MONTGOMERY COUNTY HISTORIC PRESERVATION COMMISSION
STAFF REPORT

Address:	7 W Kirke Street., Chevy Chase	Meeting Date:	12/07/2022
Resource:	Contributing Resource Chevy Chase Village Historic District	Report Date:	11/29/2022
Applicant:	Lucy Byrne, Architect	Public Notice:	11/23/2022
Review:	HAWP	Tax Credit:	n/a
Permit No.:	1012774	Staff:	Winnie Cargill
Proposal:	Generator Installation

The applicant proposes to add a 48-kilowatt generator behind the garage.

ARCHITECT
Thomson & Cooke Architects, PLLC
Attn: Neal Thomson
5155 MacArthur Blvd, NW
Washington, DC 20016
(202) 686-5583 Phone
neal@thomsoncooke.com

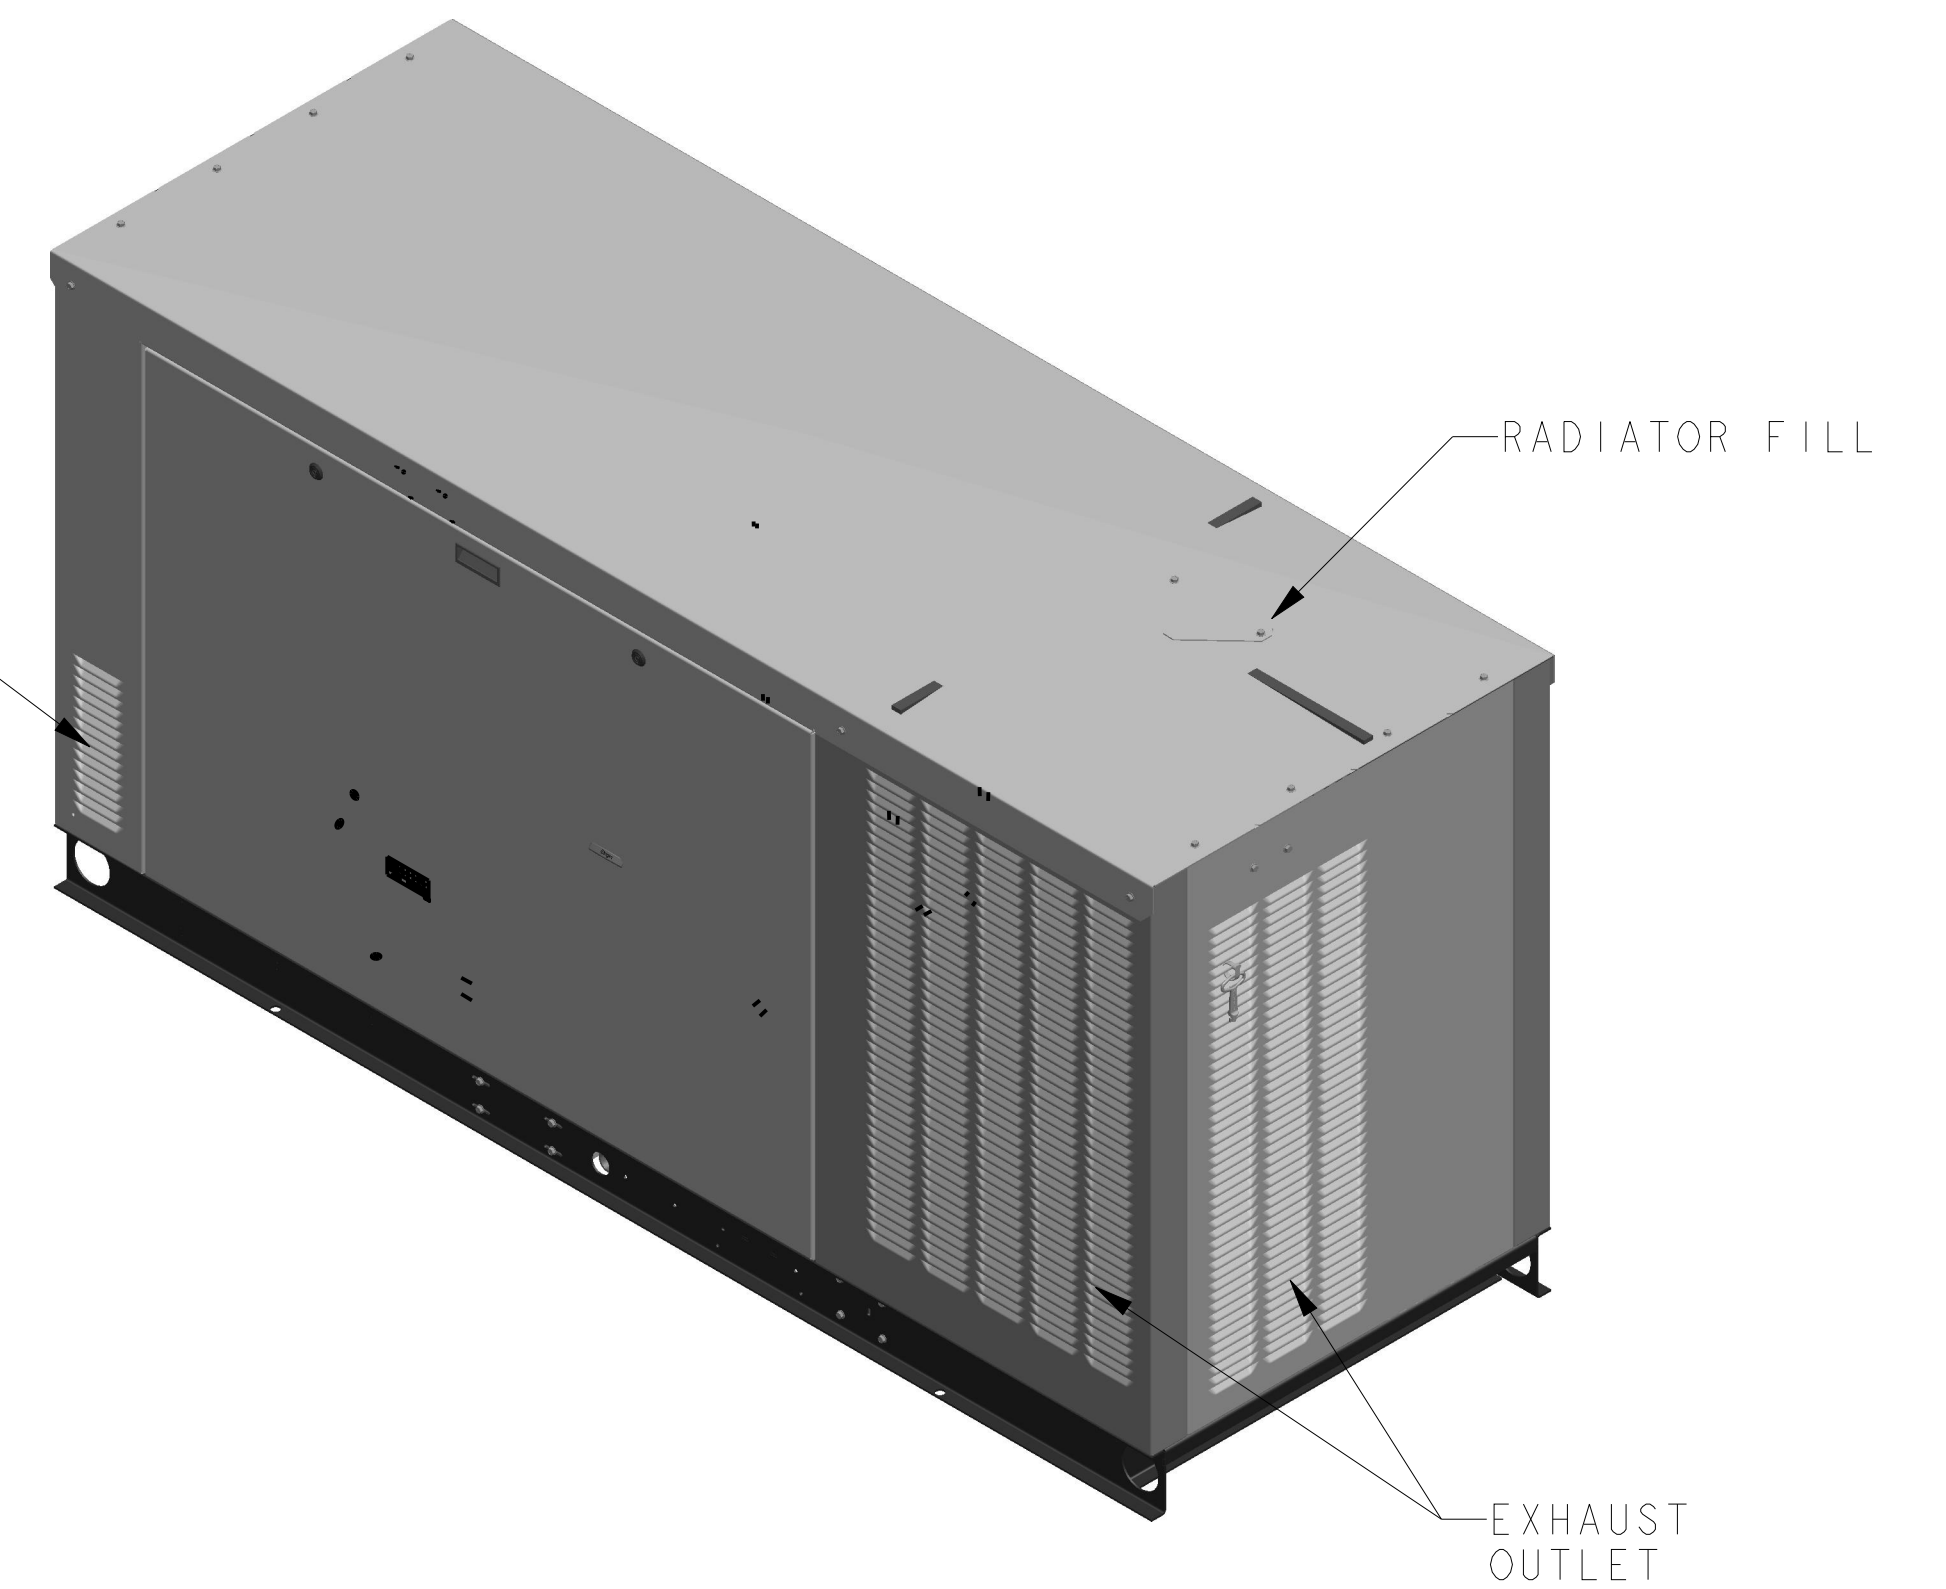
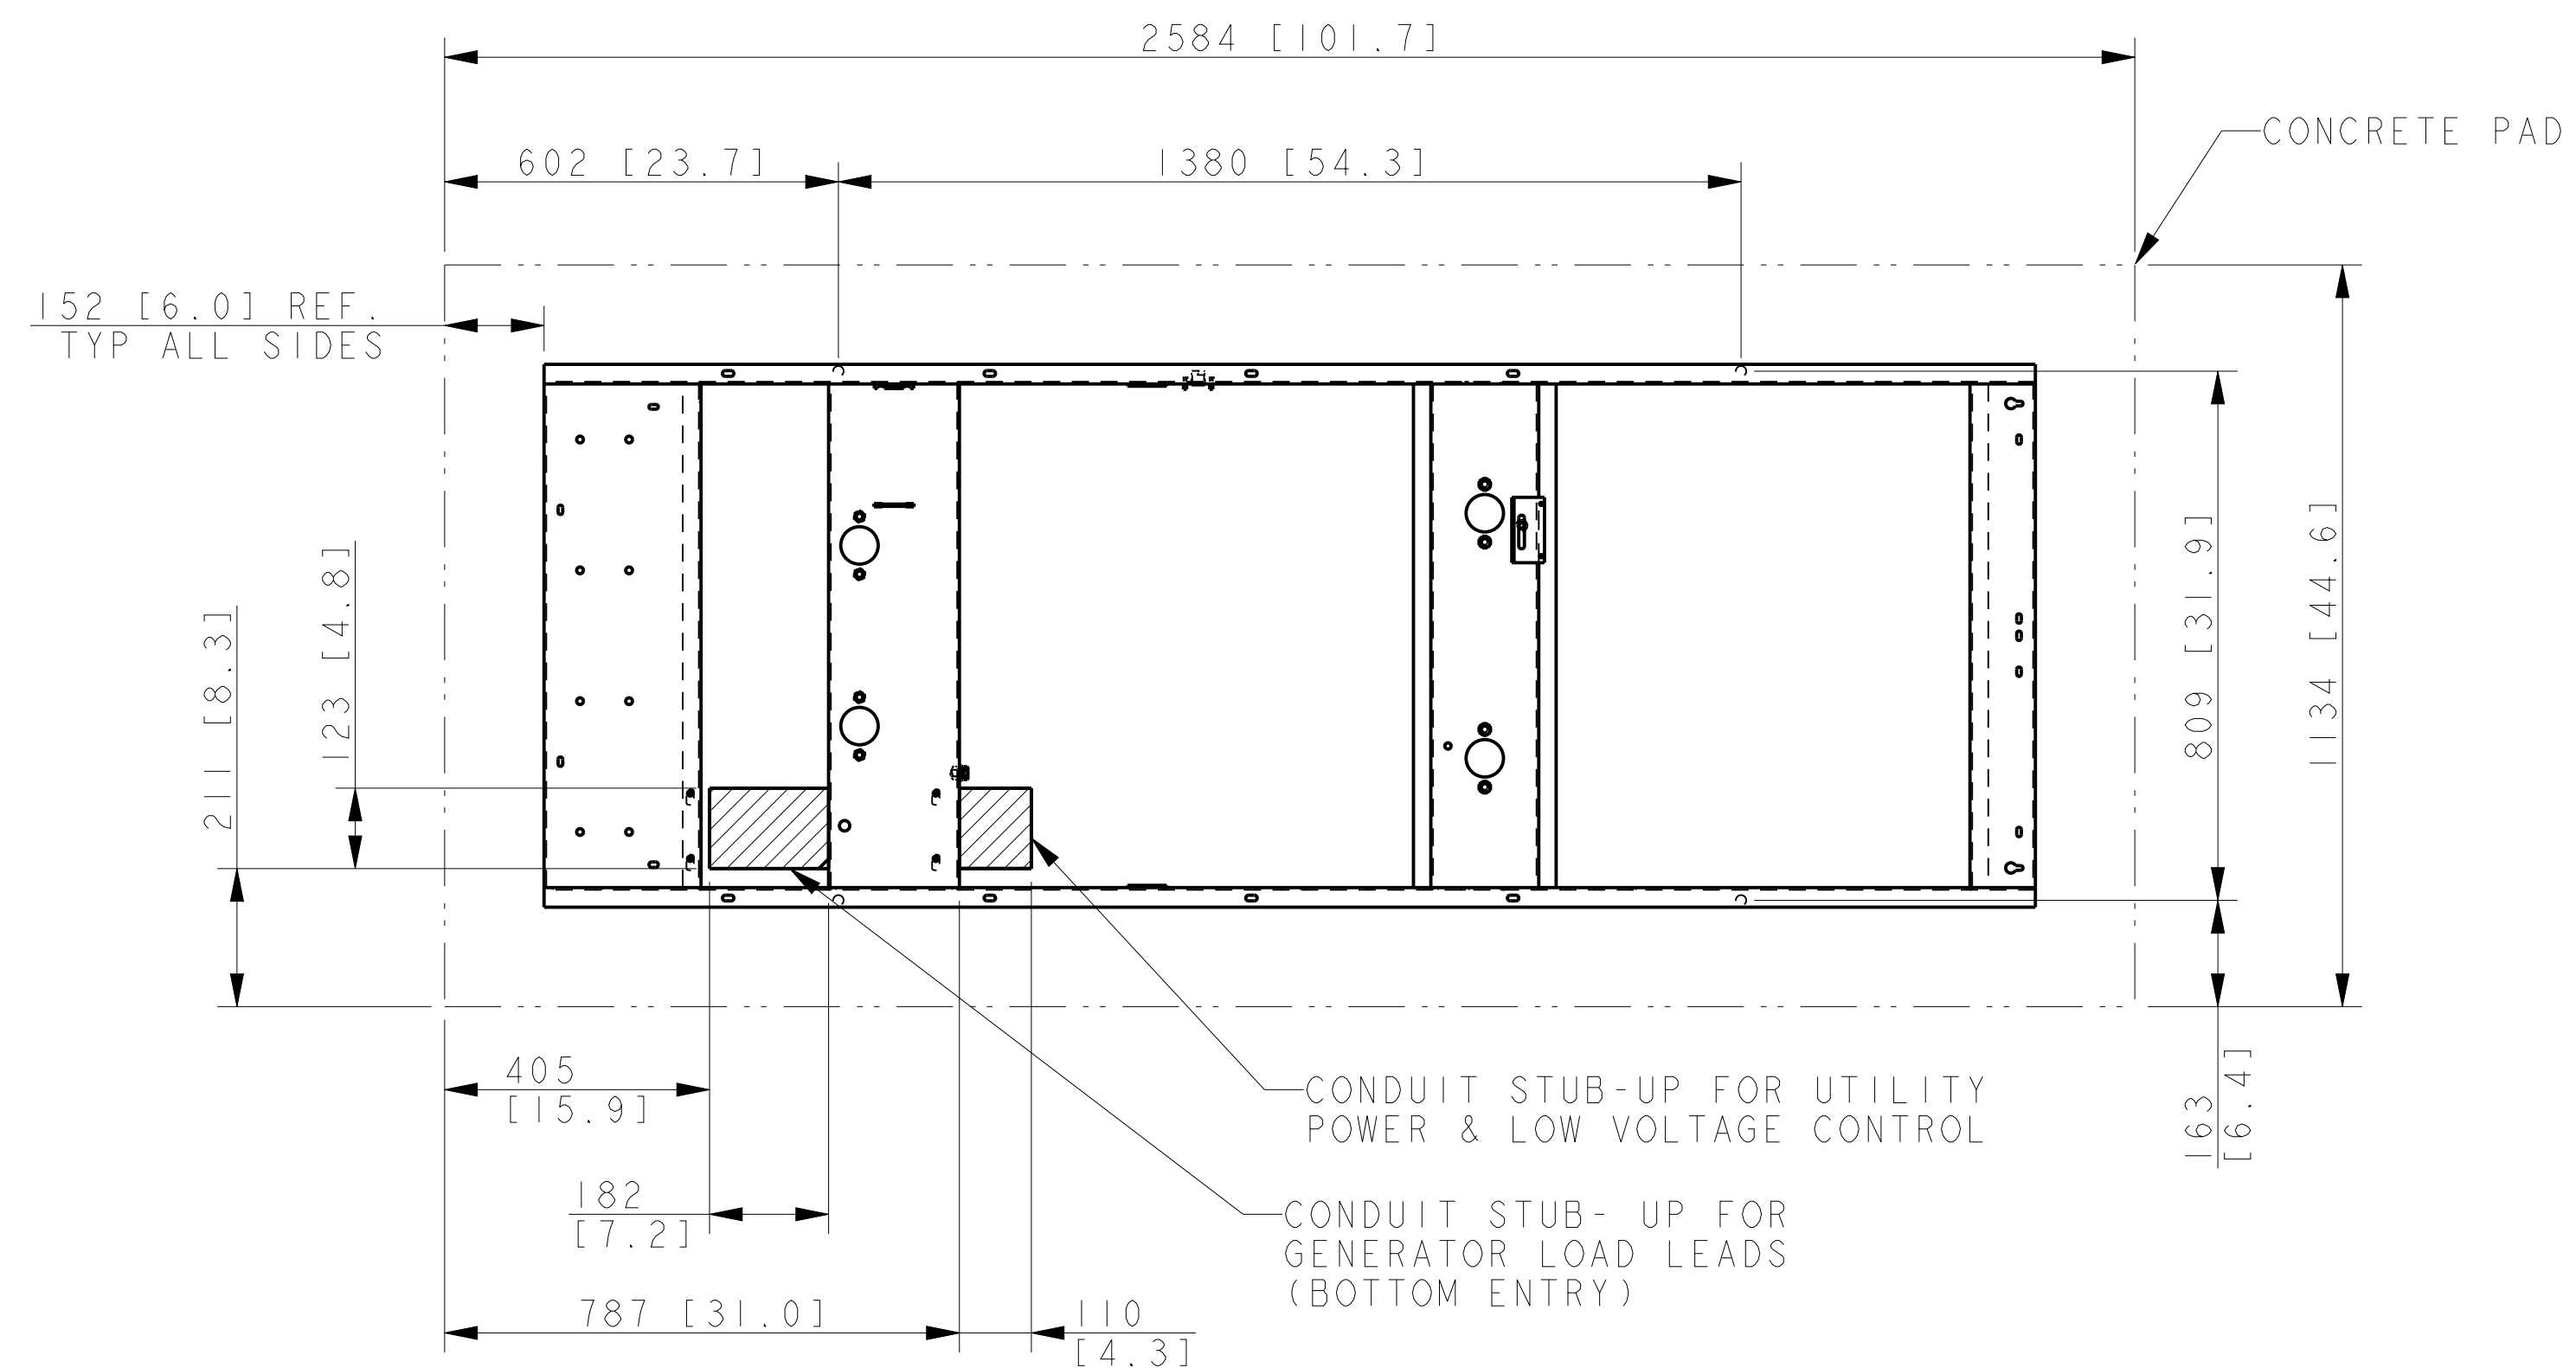
The applicant proposes to install a 48-kilowatt backup generator on a concrete pad to the north side of the garage, in the location of an existing air conditioning unit and water tank. The proposed generator measures 7.48' x 2.74' x 3.875' (seven point four eight feet wide by two point seven four feet by three point eight seventy-five feet tall). The generator will be installed 7' (seven feet) from the left (east) property line and 5.8' (five point eight feet) to the south of the north property line.

Staff finds the generator will not be at all visible from the W. Kirke St. right-of-way, because its view is blocked by the garage. From Lenox Pkwy., views of the generator will be obscured by the existing privacy fence. However, in the absence of that fence and vegetation, the generator would be visible from Lenox Parkway.

Staff finds that the proposed generator is entitled to a very lenient level of scrutiny based on the *Design Guideline* policy for alterations that are not at all visible from the right-of-way. Staff additionally finds the proposed generator is far enough from the adjacent historic houses that it will not have a visual impact on their historic character. Staff finds, the proposed generator is not out of scale with the subject property and surrounding streetscape and should be approved under the *Guidelines* as a matter of course; and 24A-8(d).

Staff further recommends the applicant continue to maintain or expand the greenery surrounding the generator location to mitigate the sound and exhaust when it is in operation. Because the *Guidelines* require HP review in the absence of any vegetation, this is only a recommended course of action and requires no further review by the HPC.

Staff recommends that the Commission **approve** the HAWP application under the Criteria for Issuance in Chapter 24A-8(b)(2) and (d), having found that the proposal will not substantially alter the exterior features of the historic resource and is compatible in character with the district and the purposes of the *Chevy Chase Village Historic District Guidelines* ;
